CORREGINDUM No -1 dated 20.03.2008

- C) Clarification on vendor's queries received till date on Enquiry no. 4573285 dated 29.02.2008 for UPS Package are as under

Scale 1:75	C5	=20C00	+	/	A1
BALLIA-BHIWADI PROJECT 2500MW HVDC BIPOLE TERMINAL PACKAGE CONVERTER STATION (BHIWADI)				PTD H121/P-004364/EC5.842.CH	
				CONTRACT AGREEMENT No.C-46002-S656-1/CA-I	
			Date	01.08.07	CONTROL BLDG. (FIRST FLOOR)
			Drawn	JUGI	
			Appr.	RK/NK	
			Norm	RKOUL	(0)E50105 - A4017 - V003 - B
B	THIRD ISSUE	10.12.07	KV	Siemens AG	
A	SECOND ISSUE	20.10.07	KV		
0	FIRST ISSUE	01.08.07	RK		W.O. No. 86012/TB-2-291-316-212A
Rev.	Remarks	Date	Name

FIRST FLOOR PLAN
(ATEL +5.500)

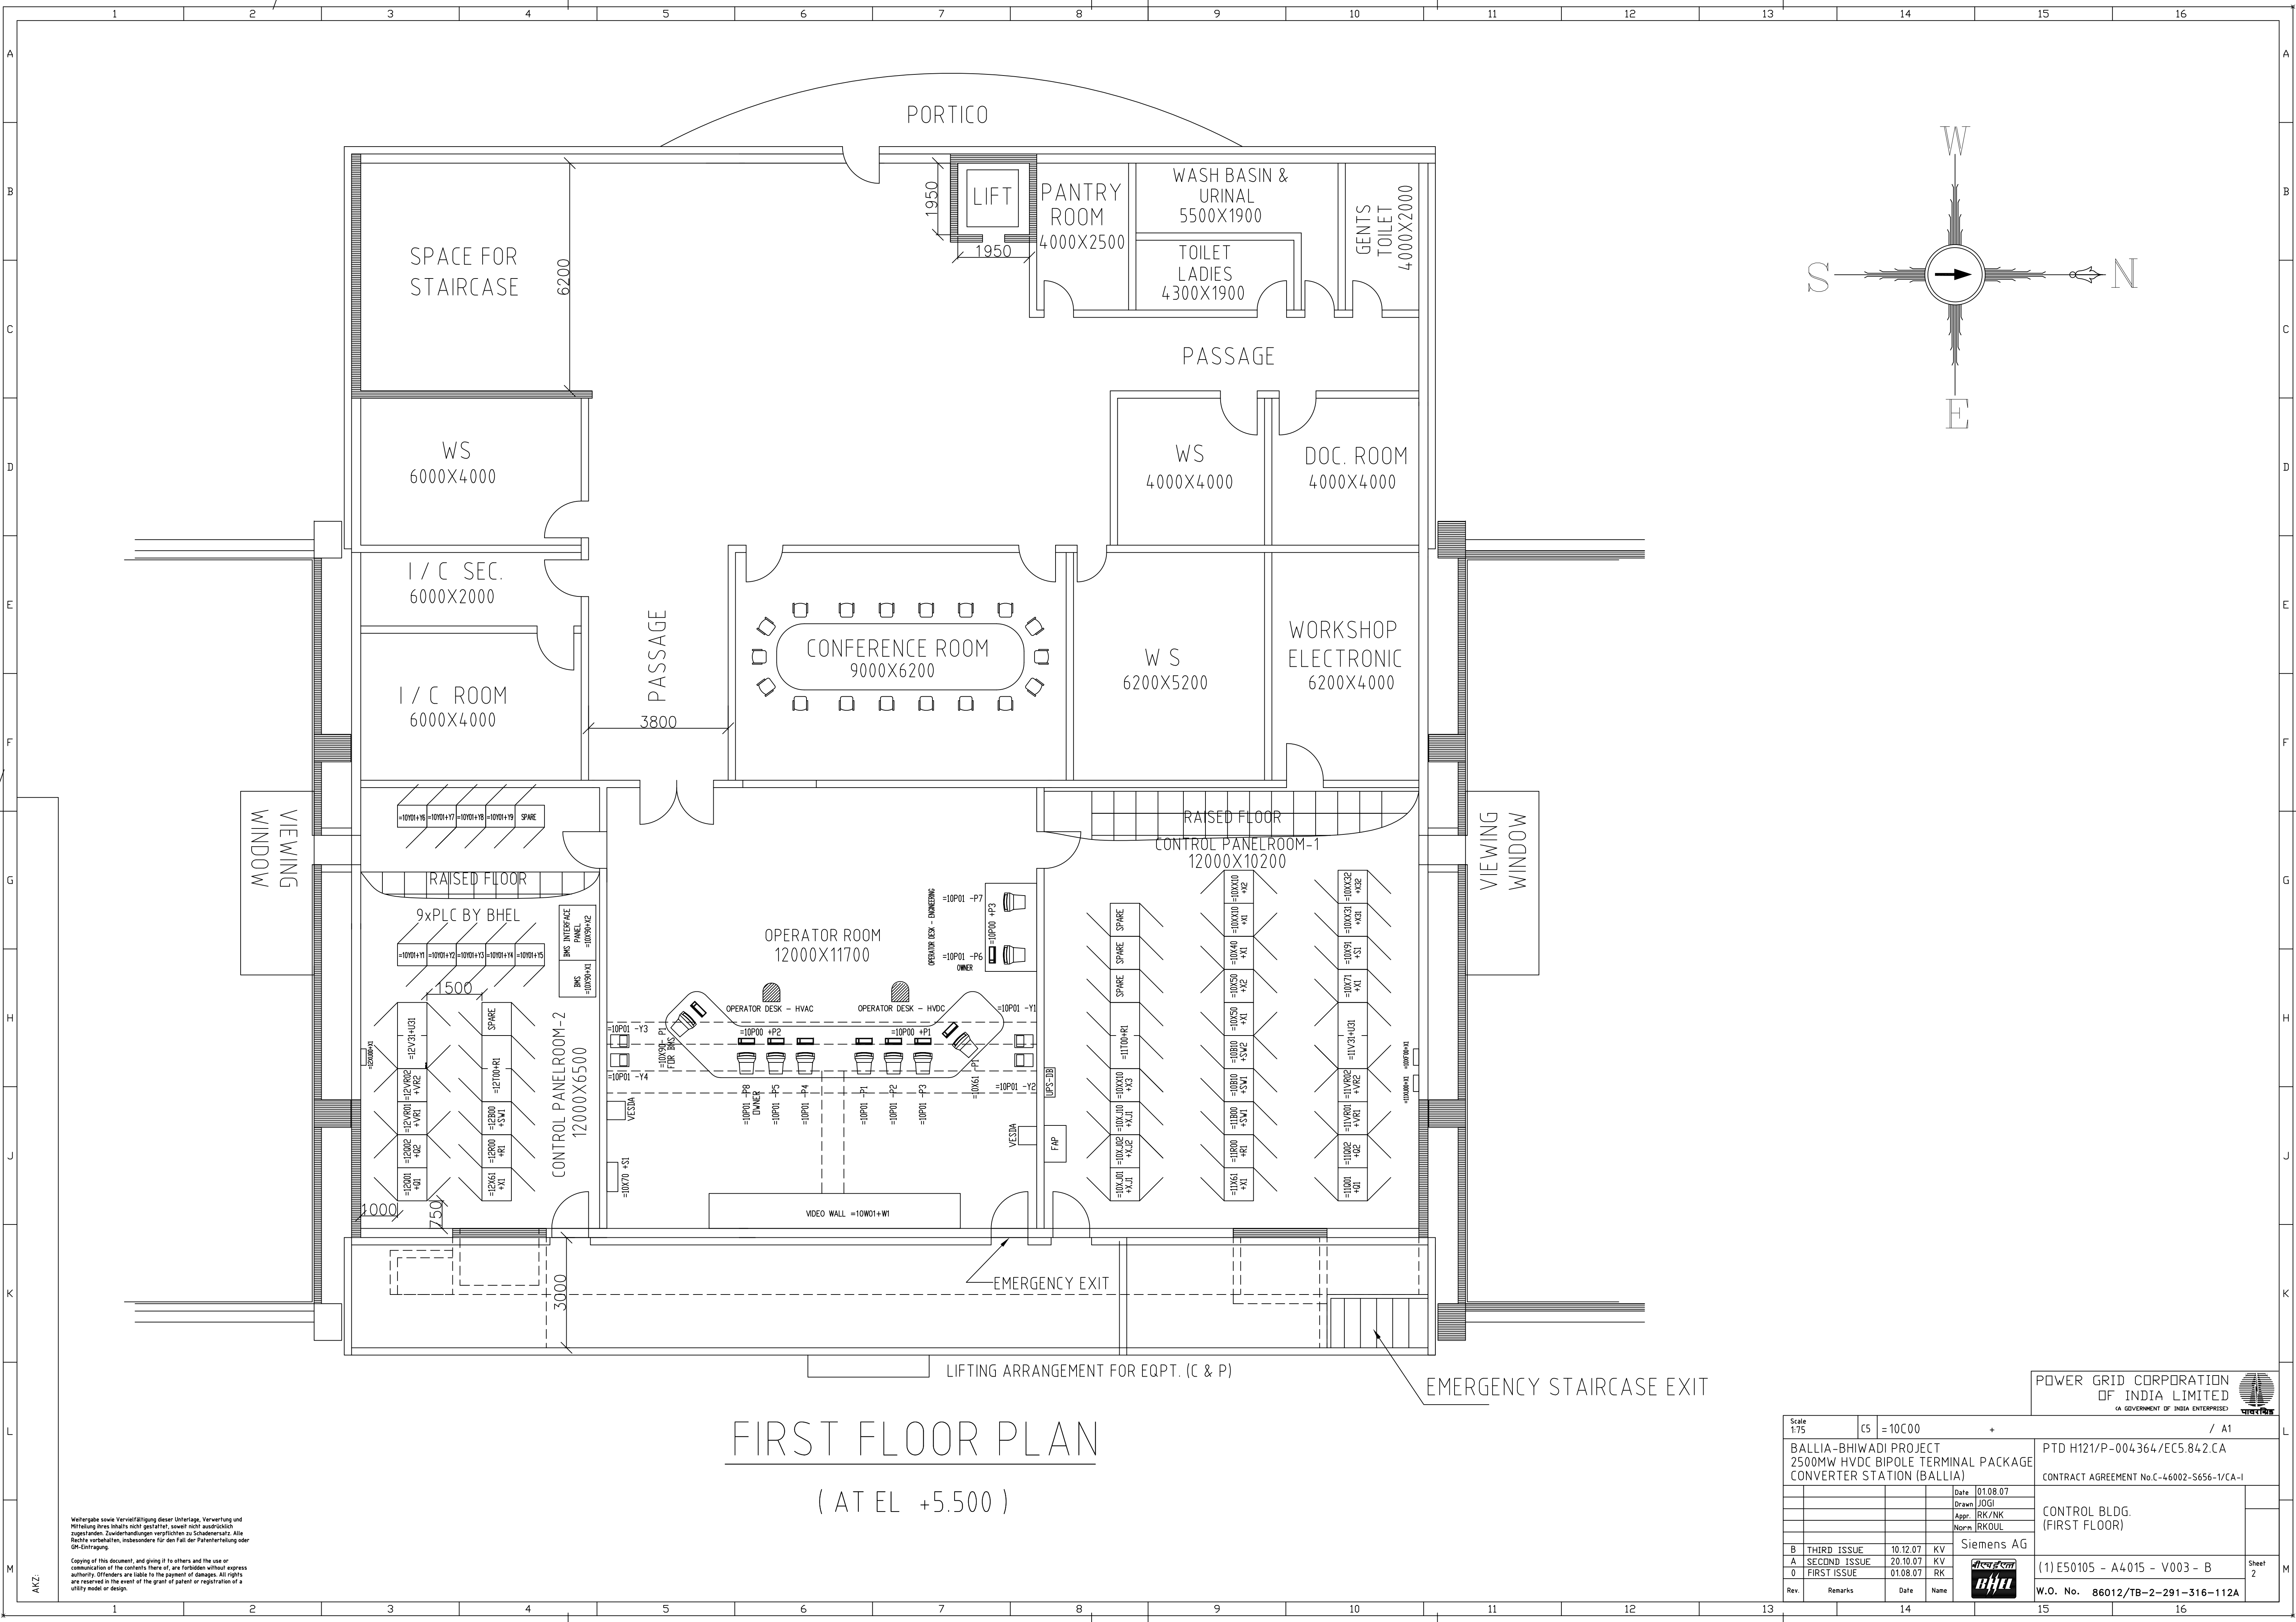
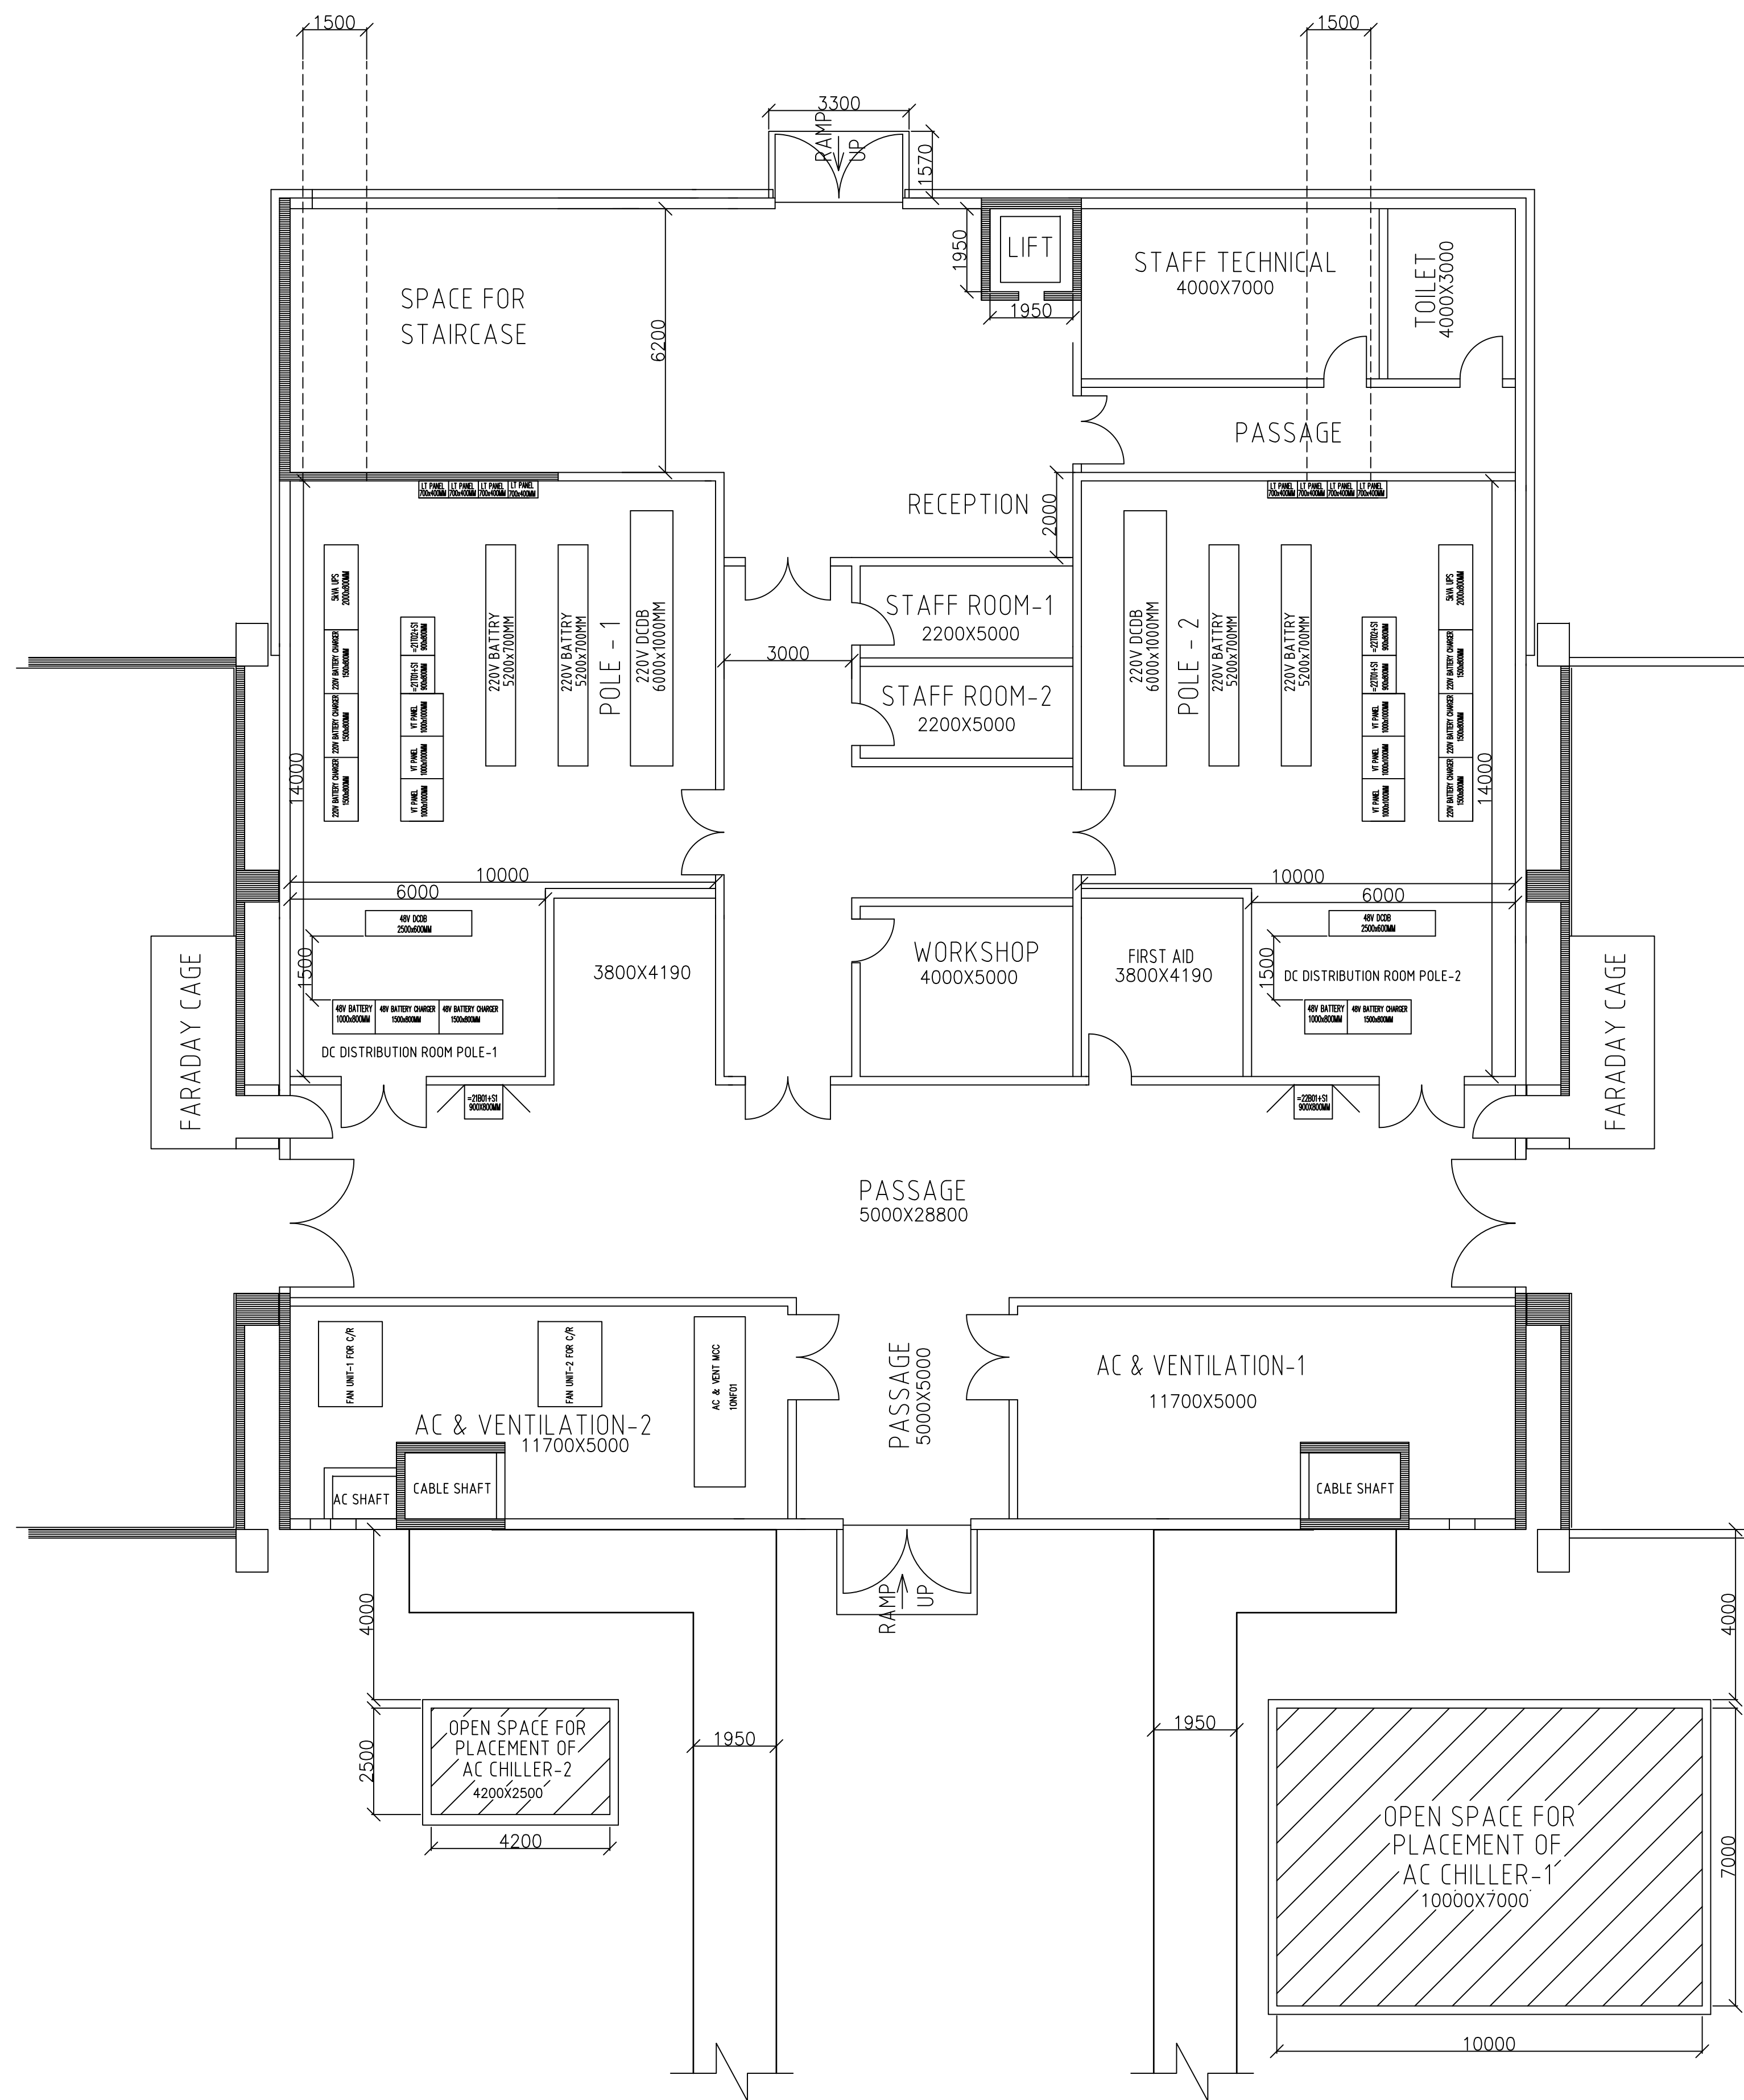
| Query 3) | Please provide us exact length and rating of Power, control and network cable. |

| Reply | Exact length to be calculated by the bidders at detailed engineering stage however the control room building Layout drawing is enclosed for your reference |
